Subject: Request for Class 2 Permit Modification to the Los Alamos National Laboratory (LANL) Hazardous Waste Facility Permit for Technical Area 54, Building 38, West, EPA ID No. NM0890010515

**Class 2 Permit Modification Request for
Technical Area 54, Building 38 (TA-54-38) West
Los Alamos National Laboratory Hazardous Waste Facility Permit
January 2013**

LA-UR-12-27049

Figure G.16-1: Technical Area 54, Building 38 (High, Low Bay, and Loading Dock Sampling Locations)

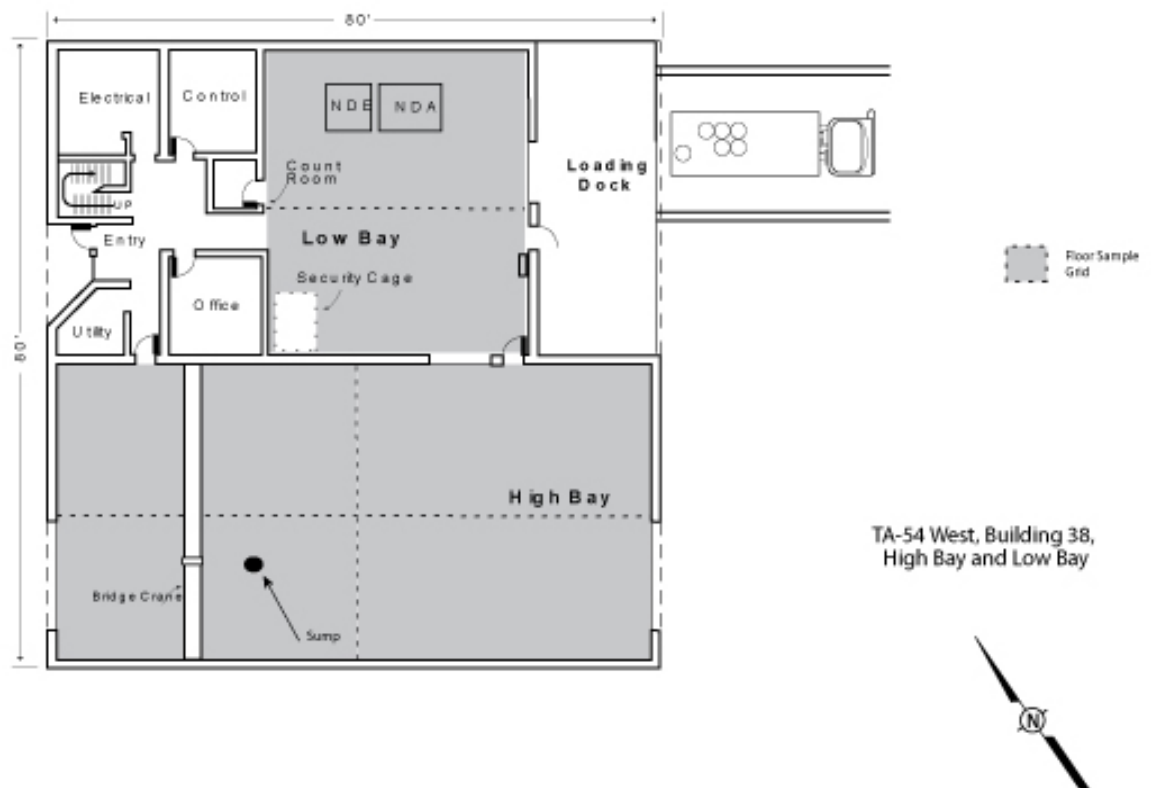
Attachment G.16, Figure G.16-1	Figure has been replaced.	Change has been made to illustrate the larger footprint of the entire High Bay and Low Bay as the permitted unit boundary, incorporate sample areas for the larger footprint, and remove the loading dock sample locations.
Attachment G.17, Section 6.1, Last paragraph	Sample locations for the loading dock have been added.	Change has been made to correct the location of the loading dock sampling requirements within the closure plans.
Attachment G.17, Figure G.17-1	Figure has been replaced.	Change has been made to correct the location of the loading dock sample areas within the closure plans. The figure was also changed to remove a structure (357) that does not exist at the unit and is not included within either Figures 9 or 37 in Attachment N.
Attachment J, TA-54, West Indoor	Operating capacity has been increased.	Change has been made to increase the operating capacity of the unit to allow the flexibility of managing shipments of larger containers.

- a. ~~four~~ nine wipe samples from the High Bay (*see* Figure G.16-1):
1. ~~two~~four from the floor;
 2. one from ~~the~~each wall; and
 3. one from the sump;
- b. ~~one~~six wipe samples s from the Low Bay (*see* Figure G.16-1):
1. two from the floor; and
 2. one from each wall.
- c. ~~one from the floor; and~~
- d. ~~two wipe samples from the Loading Dock areas identified as 'sample area 1' and 'sample area 2' (*see* Figure G.16-1)~~

Figure G.17-1: Technical Area 54 West Outdoor Container Storage Unit Grid Sampling and Additional Sampling Locations

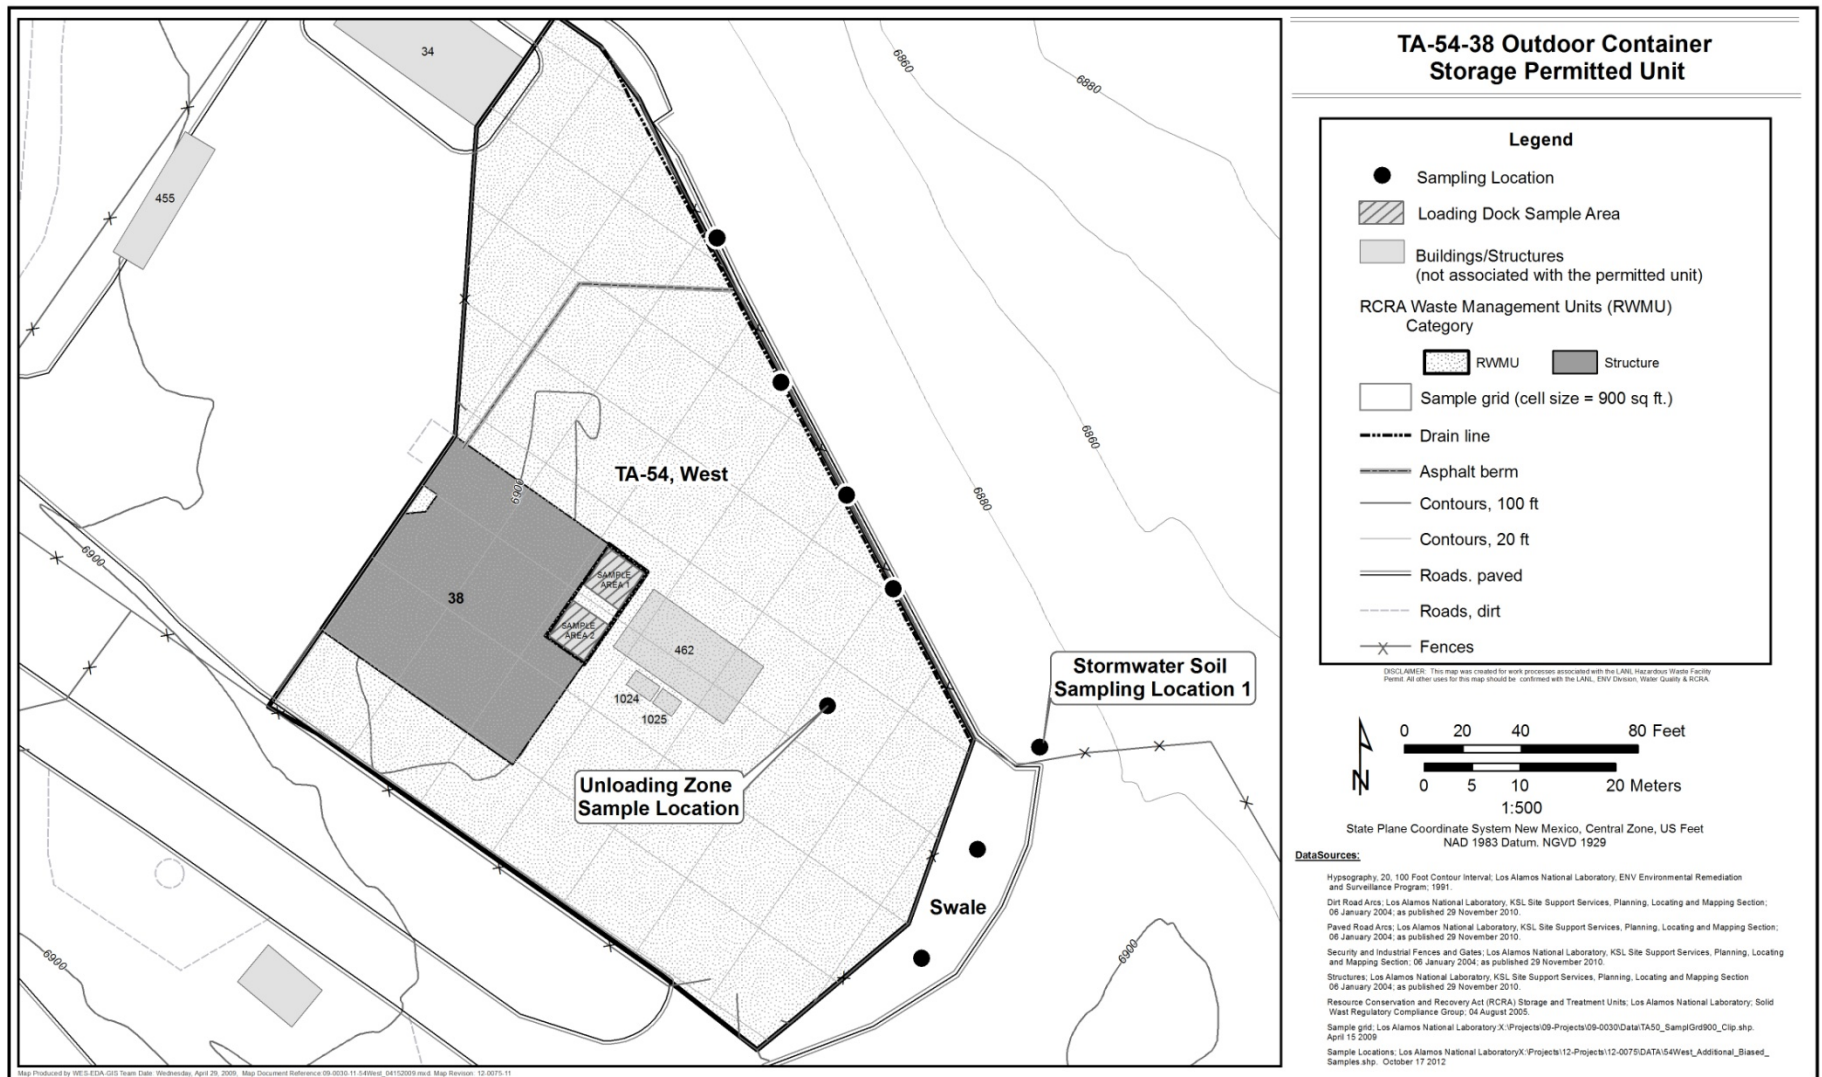
Permit Attachment G.17, *Technical Area 54 West, Outdoor Container Storage Unit Closure Plan*, has been revised in Sections 6.1 and on Figure G.17-1 to add references to the loading dock. Section 2.0 of the closure plan already includes an accurate description of the loading dock; therefore, no changes were made to that section of the closure plan. Section 6.1 has been revised to include the sample locations for the loading dock that were previously included in Permit Attachment G.16. The sample areas have also been added to Figure G.17-1.

An additional two wipe samples are required from the Loading Dock areas identified as 'Sample Area 1' and 'Sample Area 2.' Figure G.17-1 illustrates the sampling locations discussed in this section.

Figure G.16-1: Technical Area 54, Building 38 (High, Low Bay, and Loading Dock Sampling Locations)

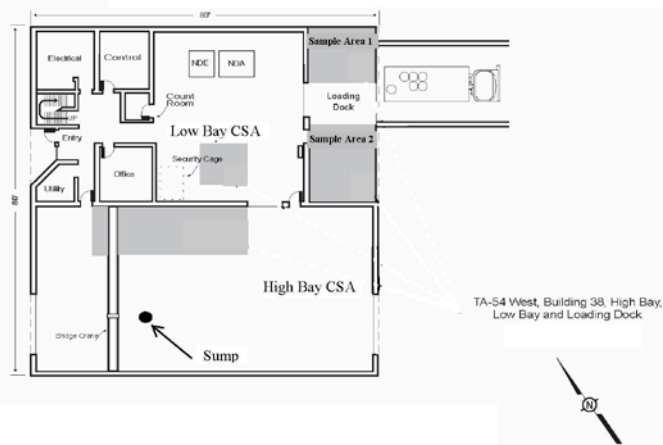
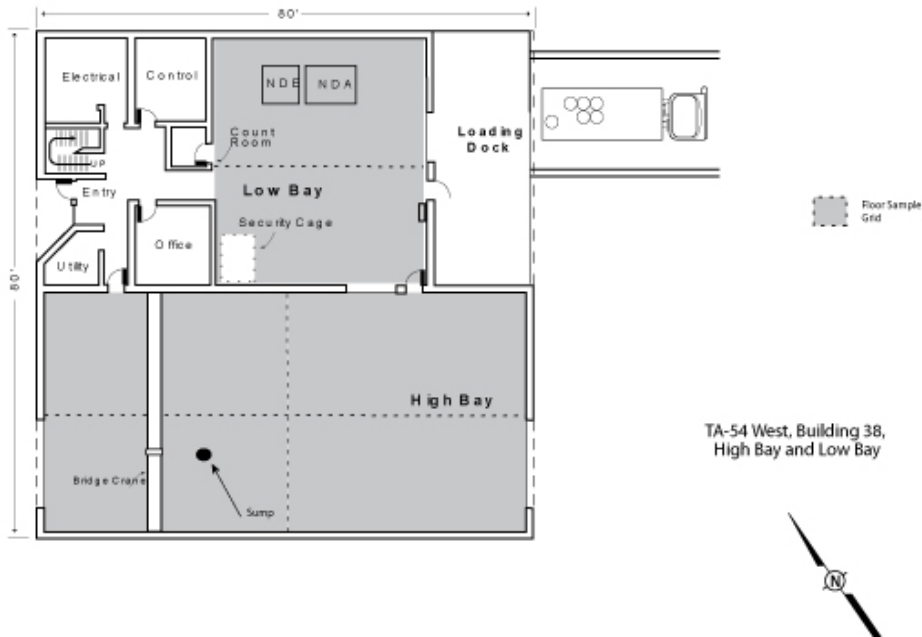
a. ~~four~~eight wipe samples from the High Bay (*see* Figure G.16-1):

b. ~~five~~one wipe samples from the Low Bay (*see* Figure G.16-1):

~~d. two wipe samples from the Loading Dock areas identified as 'sample area 1' and 'sample area 2' (see Figure G.16-1)~~
